## HISTORIC AND DESIGN REVIEW COMMISSION

September 20, 2017

**HDRC CASE NO:** 2017-159  
**ADDRESS:** 421 LABOR  
515 LABOR  
**LEGAL DESCRIPTION:** NCB 926 BLK 4 LOT N 25 OF 27 N 39 'OF 28& N TRI 14'OF 29, SE TRI 100.15'OF 4,AKA A-5  
**ZONING:** C-2, H  
**CITY COUNCIL DIST.:** 1  
**DISTRICT:** Lavaca Historic District  
**APPLICANT:** Carlton Brown  
**OWNER:** Carlton Brown  
**TYPE OF WORK:** Construction of two, two story residential structures and two, two story accessory structures

ELEVATIONS (421 Labor St)

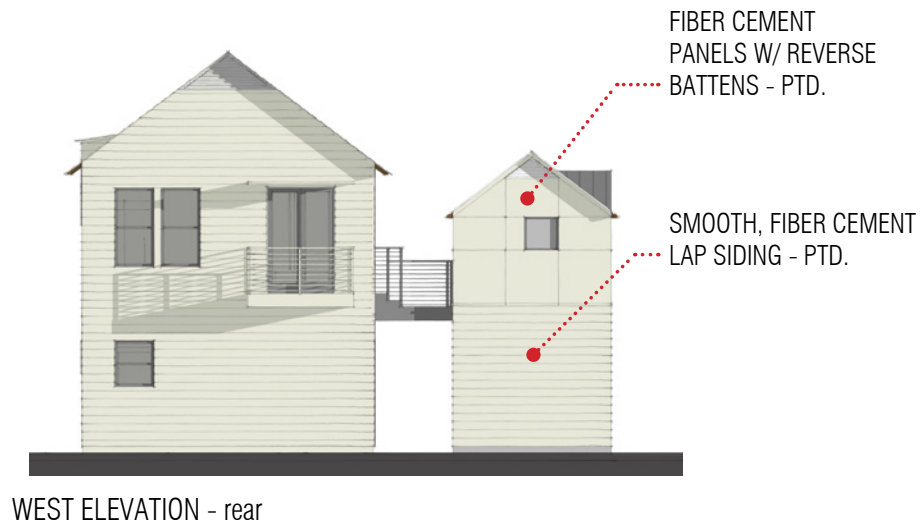
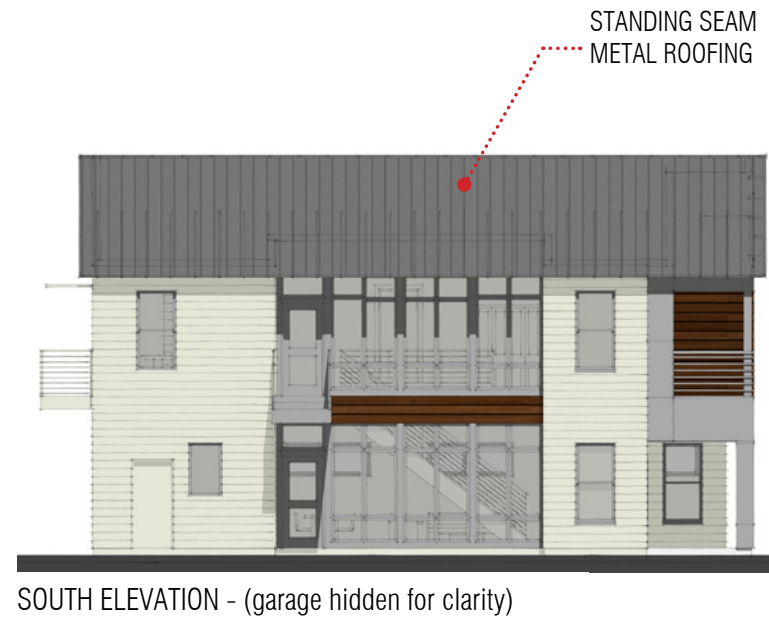
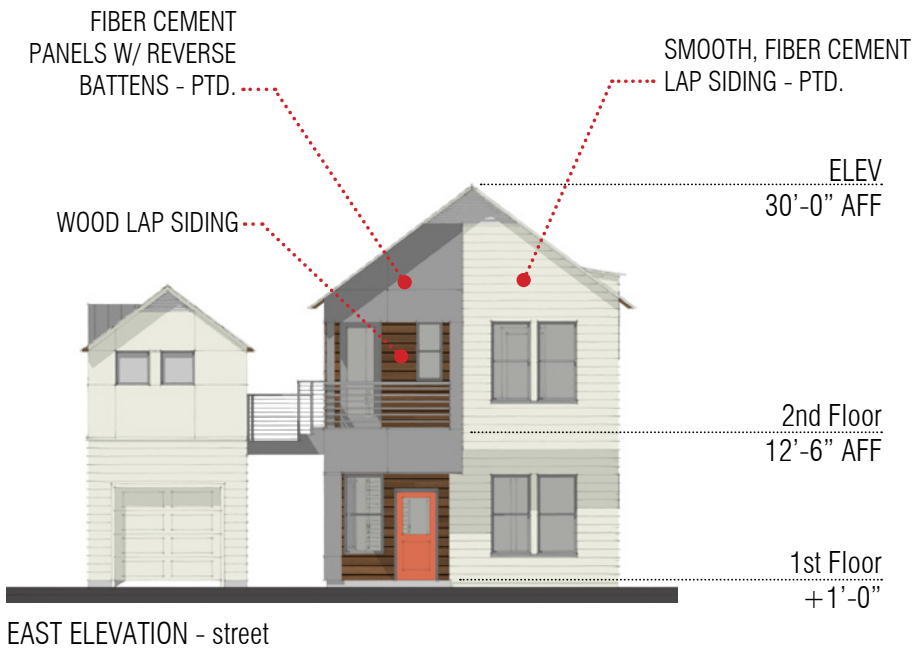
- d. SCALE & MASS – The applicant has proposed a tower toward that extends to above the top plate of the proposed second story. The proposed height of this tower is subordinate to that of the ridge height of the proposed roof. The height of the proposed roof is thirty-two feet in height. Staff finds this ridge height is considerably taller than neighboring historic structures.

- f. ROOF FORM – The applicant has proposed a front facing gabled roof. The majority of historic structures throughout Lavaca feature front facing shed roofs and both front and side facing gabled roofs. Staff finds the proposed roof form appropriate. Since conceptual approval, the applicant has proposed an eave depth of approximately two feet. Staff finds this detail appropriate; however, the exposed rafter tails should be eliminated if they do not serve a structural purpose.

- g. WINDOW & DOOR OPENINGS – The applicant has proposed window and door openings that are generally consistent in size with those found historically throughout the Lavaca Historic District. The applicant has proposed contemporary window openings that are shaped to the form of proposed roof and massing elements on both the east and north elevations.

- h. MATERIALS – Regarding materials, the applicant has proposed cement tiles, stucco, and board and batten siding. The proposed board and batten should feature boards that are feature boards that are twelve (12) inches wide with battens that are 1 – ½" wide. Generally, these materials are appropriate and consistent with the Guidelines. The proposed standing seam metal roof should feature panels that are 18 to 21 inches in width, seams that are 1 to 2 inches in height, a crimped ridge seam and a galvalume finish.

- q. ROOF FORM – The applicant has proposed a front facing shed roof. The majority of historic structures throughout Lavaca feature front facing shed roofs and both front and side facing gabled roofs. Staff finds the proposed roof form appropriate. Since conceptual approval, the applicant has introduced roof eaves with a depth of approximately two feet.

- s. MATERIALS – Regarding materials, the applicant has proposed wood lap siding, smooth fiber cement siding, panelized smooth fiber cement panels, a standing seam metal roof. The proposed standing seam metal roof should feature panels that are 18 to 21 inches in width, seams that are 1 to 2 inches in height, a crimped ridge seam and a standard galvalume finish. Staff finds that the proposed wood siding and fiber cement lap siding should feature an exposure of four (4) inches.

Staff does not recommend approval of items #1 through #4. While the applicant has made modifications to the proposed design to address previous comments, specifically in regards to architectural details and materials. The overall scale, height, and massing should be reconsidered to conform to the historic design guidelines and reduce visual impacts to neighboring historic properties.
